## EARTHQUAKE RESISTANCE OF BUILDINGS AT 734-744 COLOMBO STREET

**RE: 734-744 COLOMBO STREET - STRENGTHENING WORK**

**RE: EARTHQUAKE DAMAGE TO BUILDINGS AT**  
**736-738 COLOMBO ST, CHRISTCHURCH**

Buildings at  
734-744 Colombo Street  
1007 E1

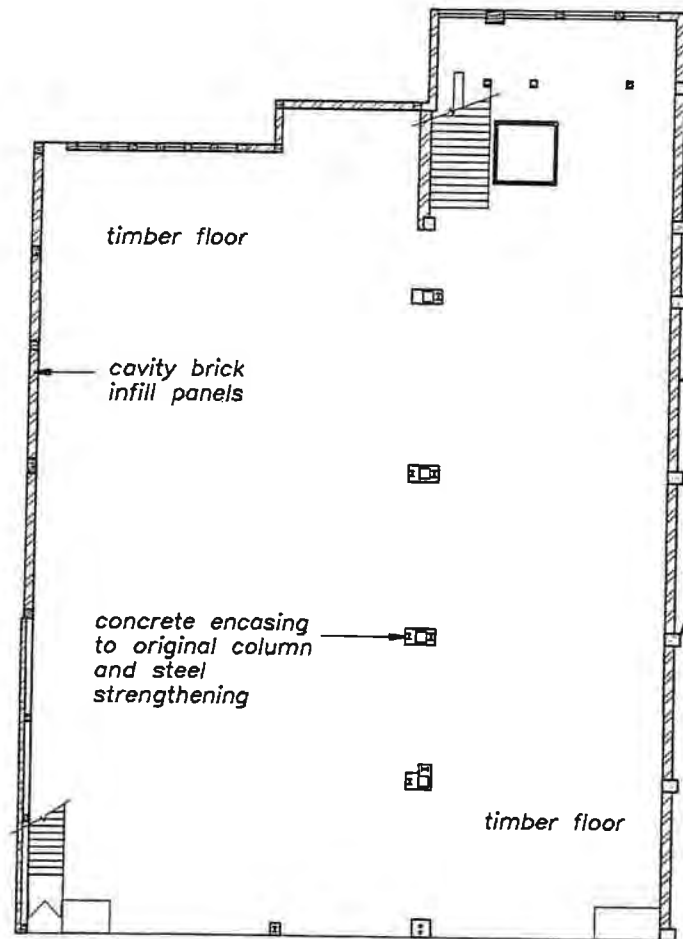
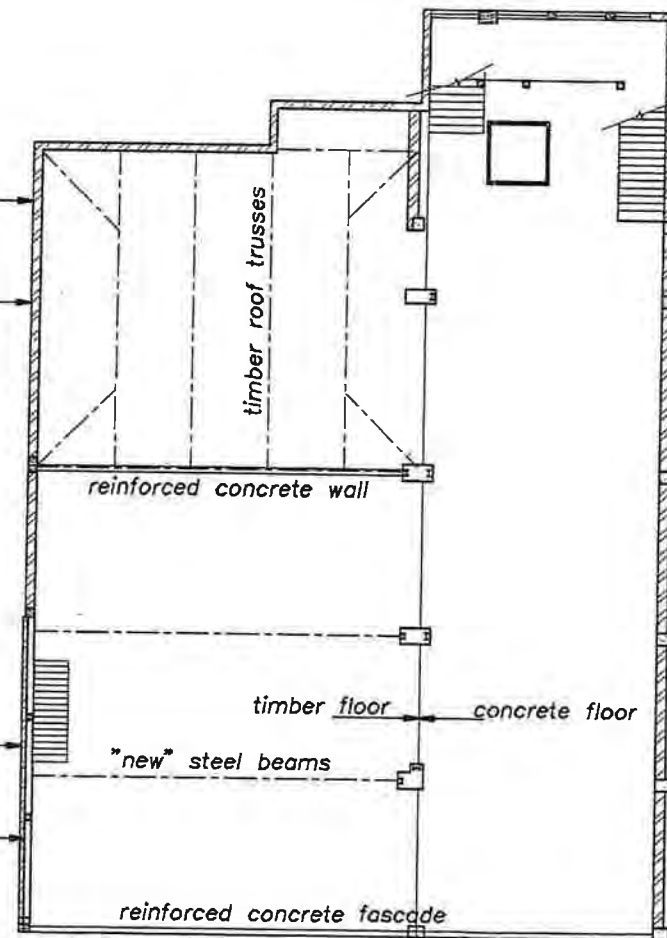
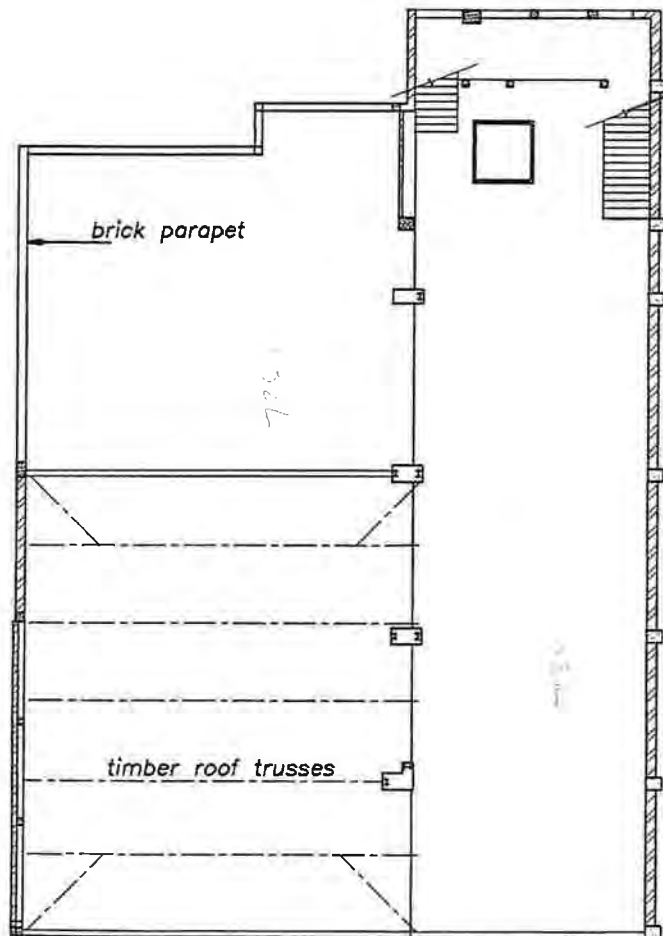
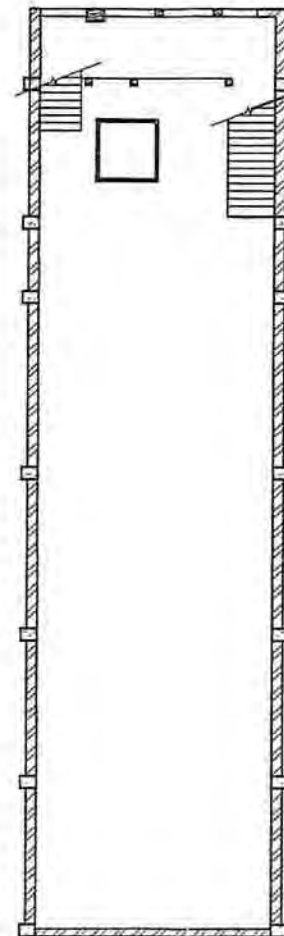
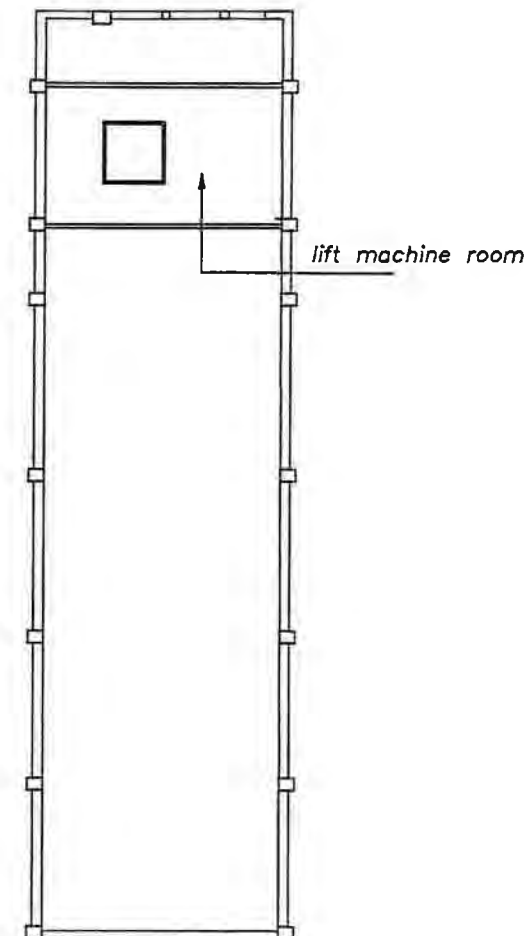
Drawings 1007 E1, E2, E3 are attached, giving a basic outline of the current structural elements.

SKETCH 1

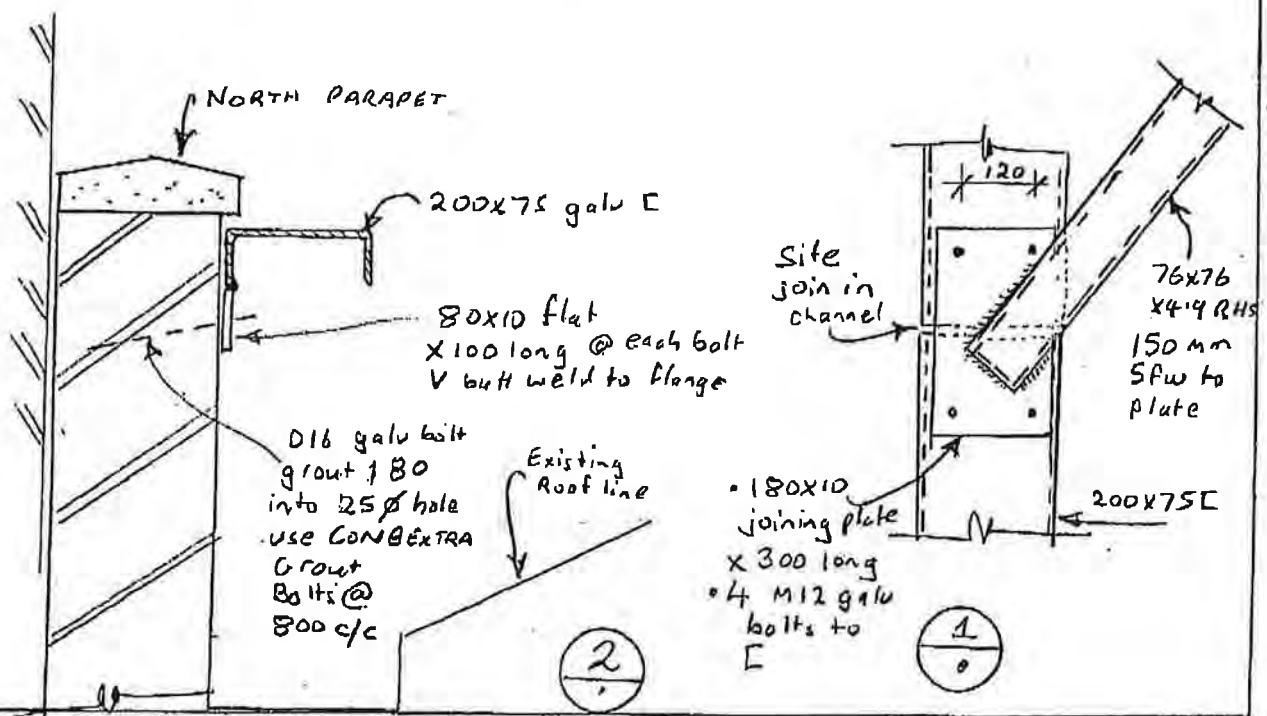
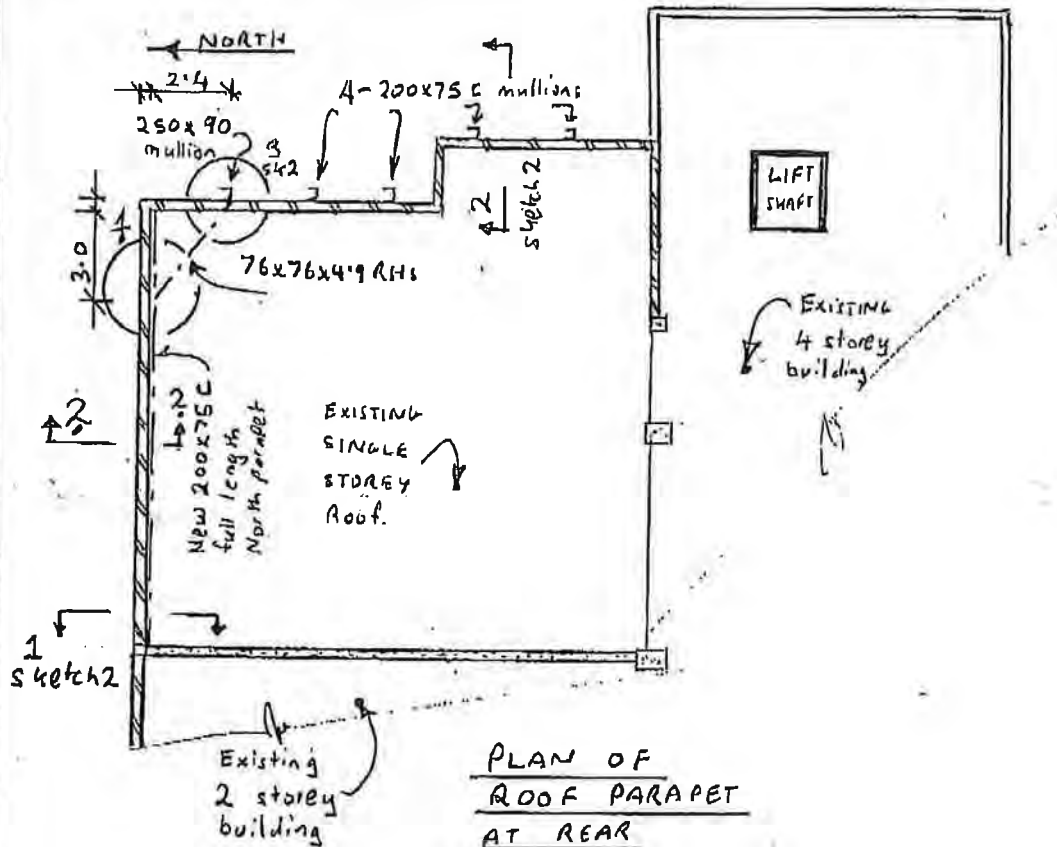
Items 3.3 c and d were completed in 1991. The brick parapets at the north and east, items 3.3 a and b, are to be strengthened in accordance with Sketches 1 and 2. The strengthening work will restrain the parapets and brick walls, as opposed to lowering or removal. With the east wall restrained the roof in the south east corner will have improved support.

SKETCH 3

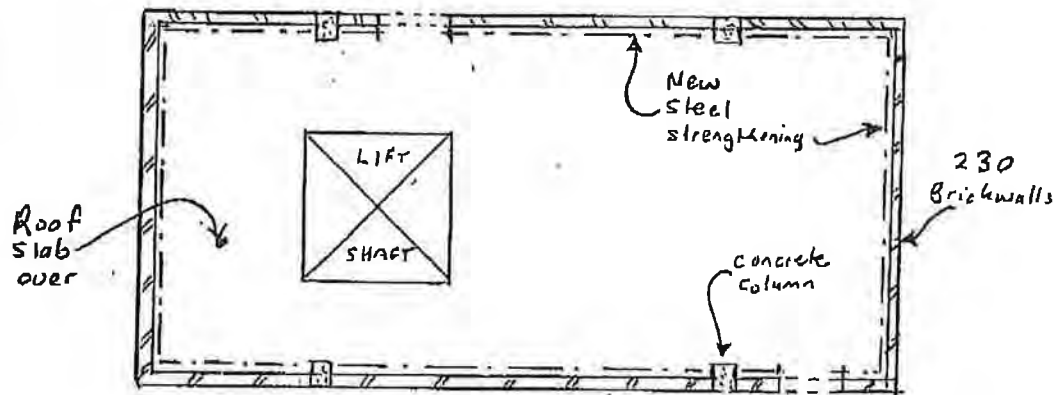
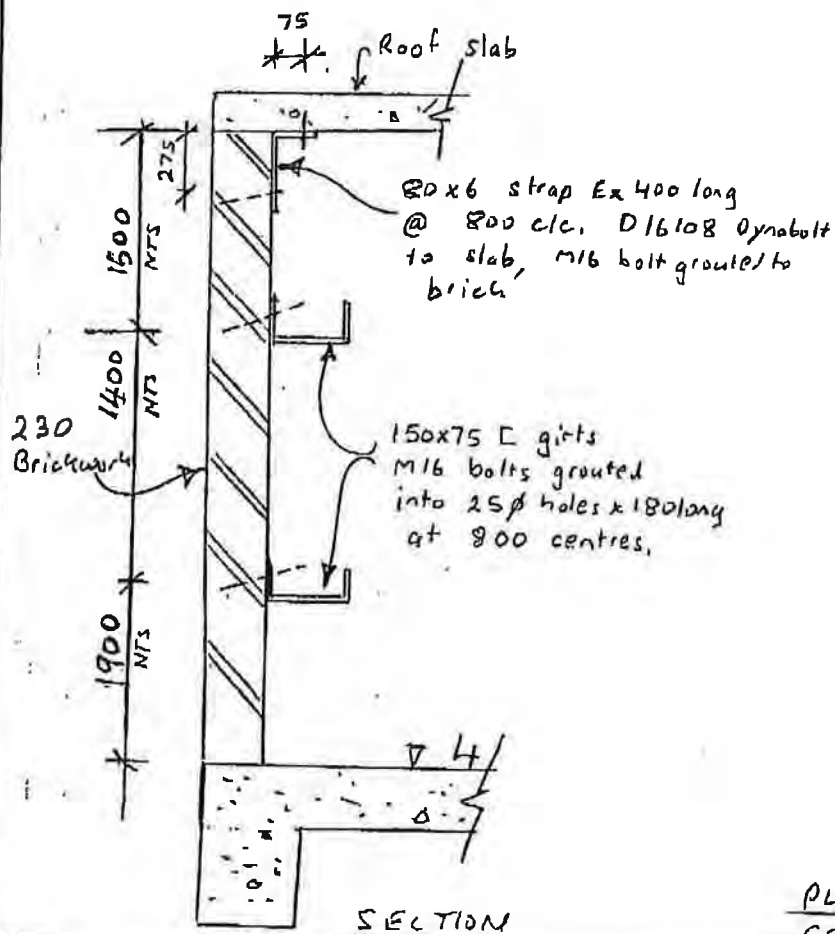
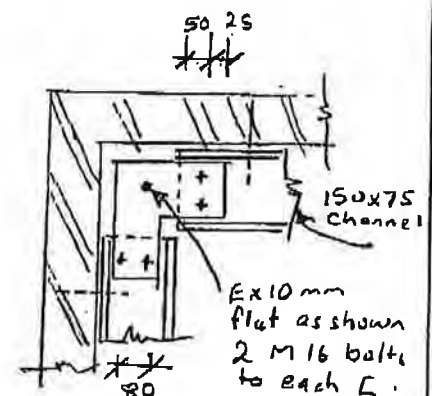
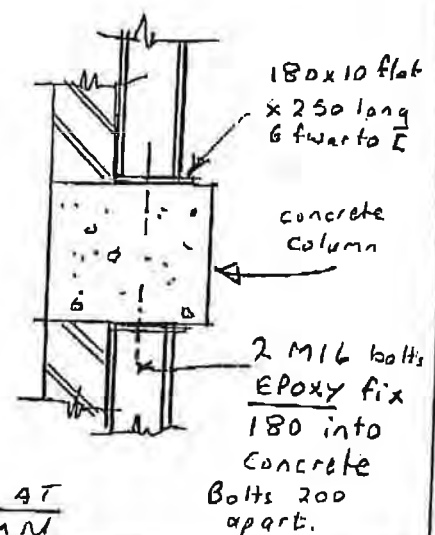
In our conclusions to the above report we recommended that remedial work be undertaken in two stages. Items 2.3 b and c were addressed in 1991 with a block wall being provided at ground floor level for C. Strengthening of brickwork to the lift machine room, item a, is addressed in Sketch 3. Existing tenancy layout and fitout make implementation of item d difficult at this point in time. It is proposed that the remedial work proposed be deferred until tenancy refurbishment is carried out. As noted in 2.2 of the report the structure possesses sufficient strength to resist 0.1g earthquake acceleration.
